RE: Tallawarra Lands Concept Plan Exhibition – NOW Comments

This letter addresses the comments by the NSW Office of Water (NOW) in their letter dated 11 January 2012 in regard to the Part 3A Concept Plan for Tallawarra Lands – Major Project Number #MP09_0131.

Figure 1. Concept Plan with riparian RCMS buffers applied by ELA, with 100m Duck Creek buffer from top of bank.

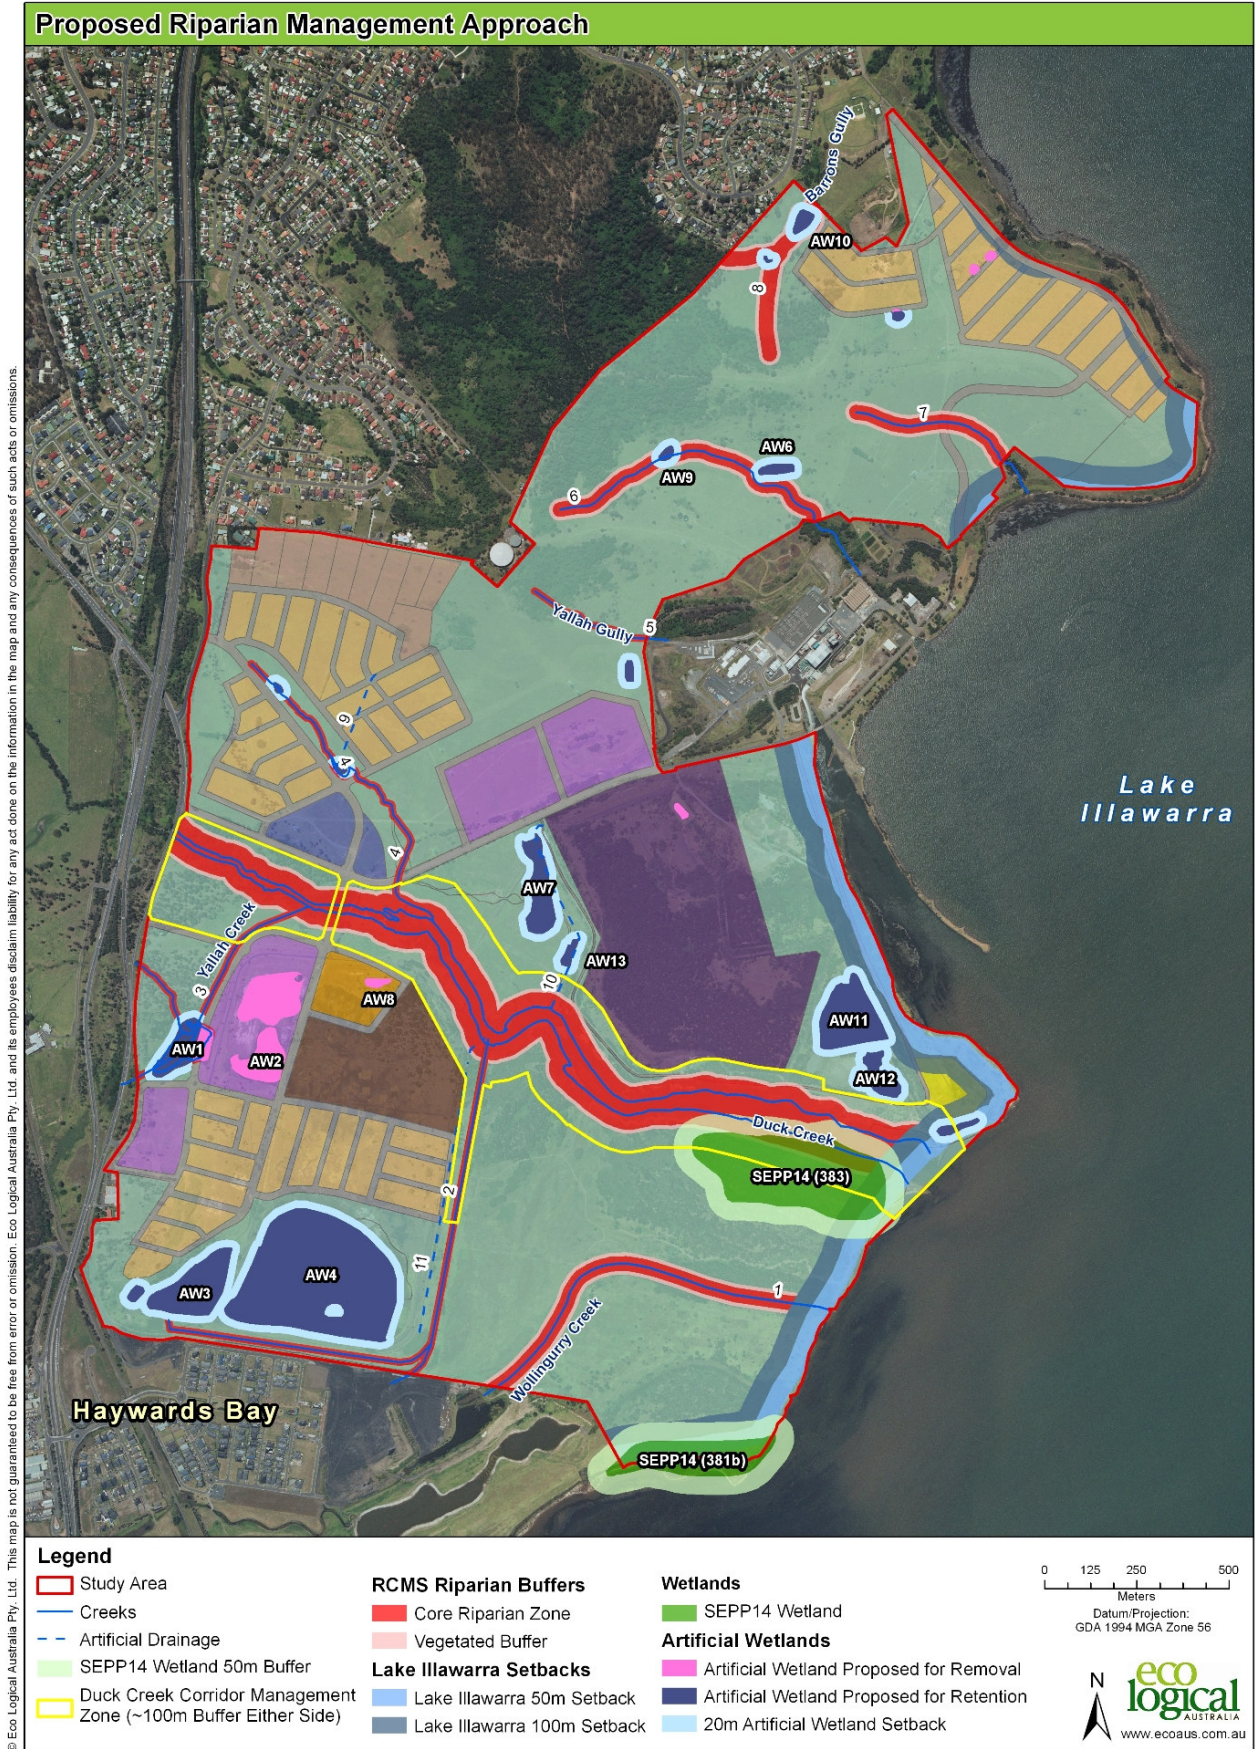
This drainage line was classified in the RAR as a category 1 drainage line – thus requiring a 40m core riparian zone (CRZ) + 10m vegetated buffer (VB). This outcome is shown in **Figure 1**. However, Duck Creek connects native vegetation in the west to SEPP14 wetlands and Lake Illawarra, and thus was recognised in the RAR as having the potential to provide regional connectivity. Current connectivity is reduced by historical land clearing and disturbance. The Vegetation Management Plan (VMP) thus sought to deliver a corridor with a 100m buffer from the top of bank to either side of Duck Creek. The specific boundaries for the Duck Creek corridor adopted

had some variations to distances determined purely by 100m from top of bank, but additional areas were added to replace any portions removed so as to deliver the ecological connectivity outcome. It is noted that the proposed corridor is well above the 50m setback (40m CRZ + 10m VB) required under the RCMS methodology.

These outcomes for Duck Creek exceed the RCMS requirements and delivers strategic outcomes within and beyond the site. However, NOW requested that this 200m wide corridor be revegetated so as to recreate a fully structured vegetation community on site. The Concept Plan proposes to fully revegetate the CRZ and VB as required by the RCMS methodology whilst also providing strategic revegetation to other parts of the Duck Creek Corridor (outside the statutory 50m setback) such that the objectives of providing a regional corridor linkage along Duck Creek can be provided. At a minimum, this additional revegetation will involve reinstating a native vegetation canopy and controlling weeds within the remaining portions of the corridor but will provide for other structural layers in relevant parts. There will be a substantial financial cost associated with the delivering this future corridor, estimated at circa \$1.8 million for works along Duck Creek alone from a total estimated cost of vegetation management works for the entire site of \$3.8 million.
